Desert Claim Wind Power Project

Final Supplemental Environmental Impact Statement

Energy Facility Site Evaluation Council

November 2009

my house looking NE to towers 92-95

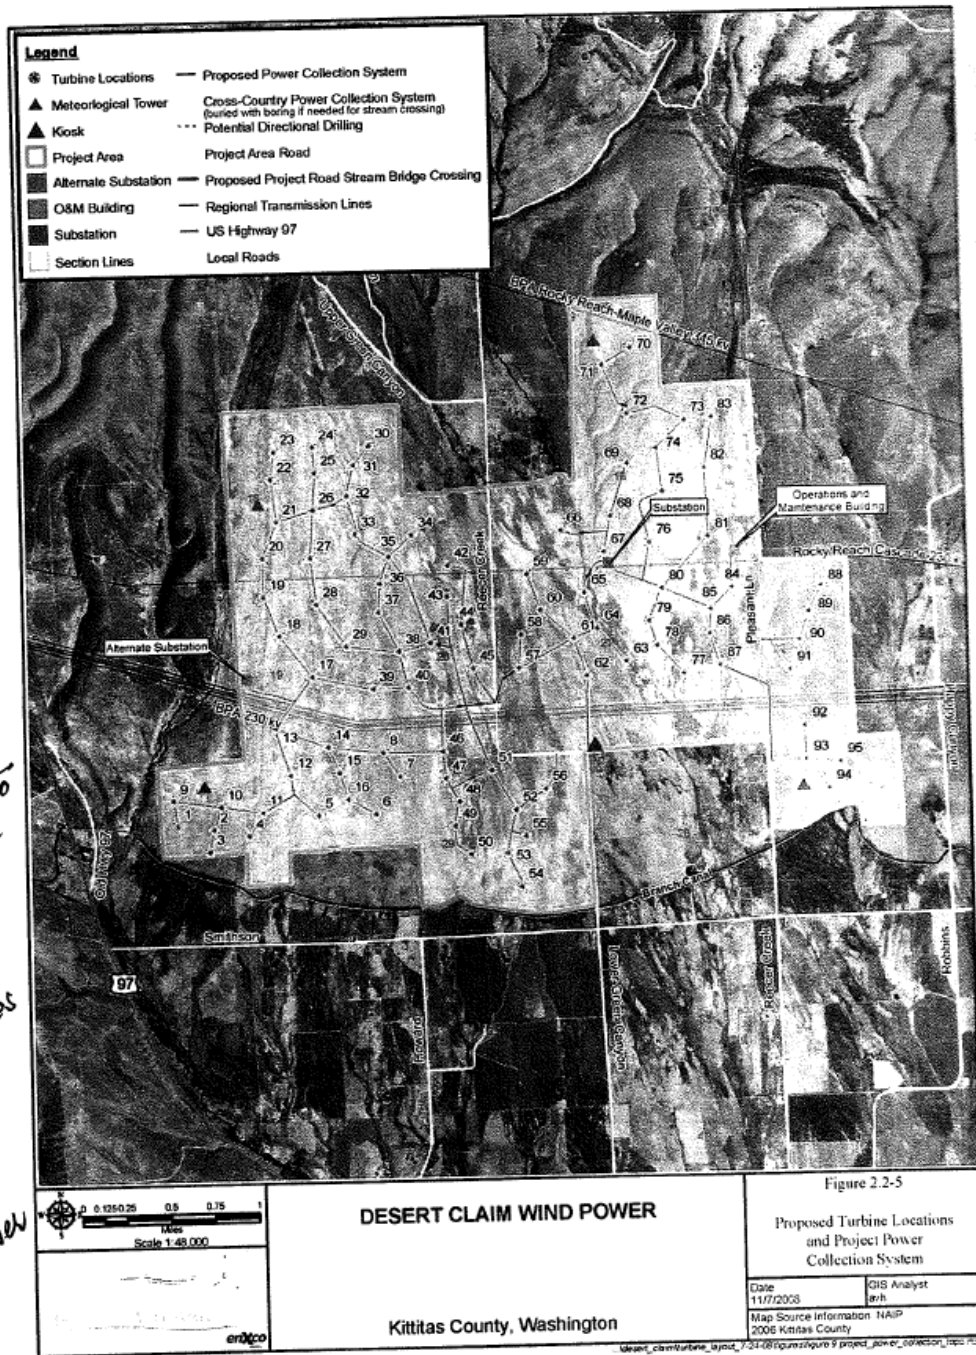
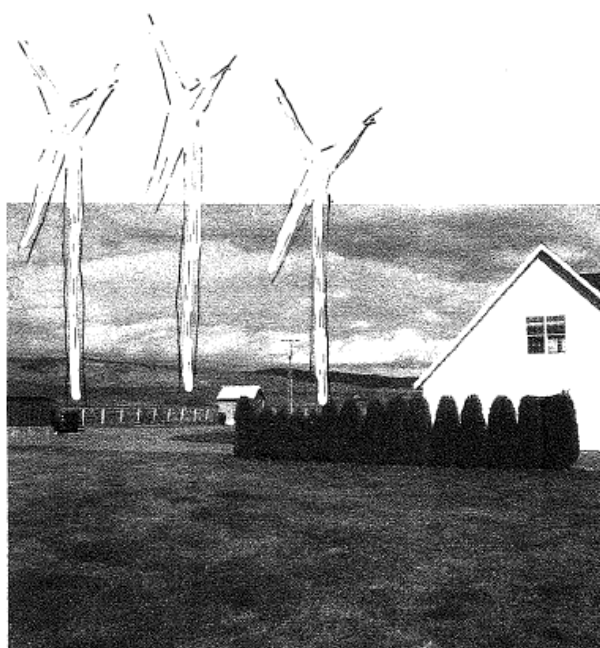
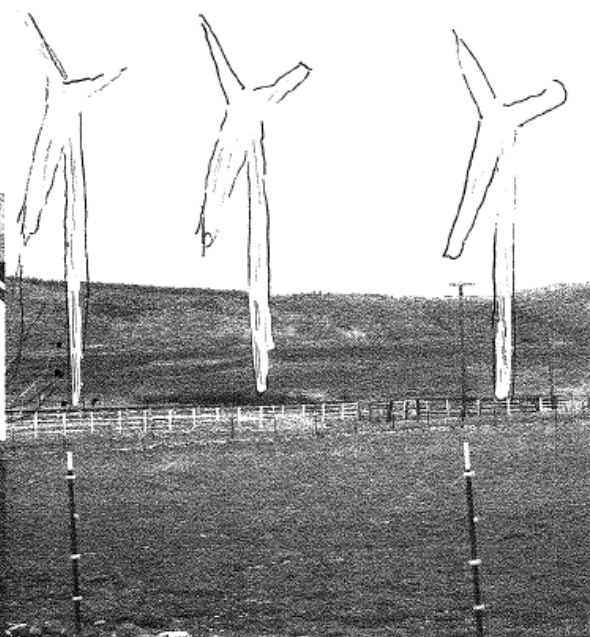
Still have 82-more than Kittitas Wind Power Project (Approved) Same 195MW

TURBINES
 1-16 (16)
 46-56 (10)
 92-95 (4)
 Total 30
 should not be
 built
 Reduce amt
 to 65 turbines

(Same as
 approved
 Kittitas Wind Power
 Project.)

view to NE From my back yard
Power Pole 60'
wind turbine 410'

The comment suggests that hundreds of residences are located near the project. The 2004 Desert Claim Final EIS, which this SEIS supplements, contains a thorough description of land use patterns in the area surrounding the Project. The SEIS Project Description (Section 2.2.1.3) generally characterizes land use in the surrounding area, and identifies residences that are located proximate to proposed wind turbines. As described in the text, and shown on Figure 2.2-3 and Table 2.2-1, seven (7) residences—excluding those participating in the Project—would be closer than 2,500 feet to a wind turbine; none would be closer than 1,640 feet, which is four times the tip height of the proposed turbines. Please refer to the response to Comment 3-5, which discusses setbacks and how visual impacts decrease with increasing distance from wind turbines.
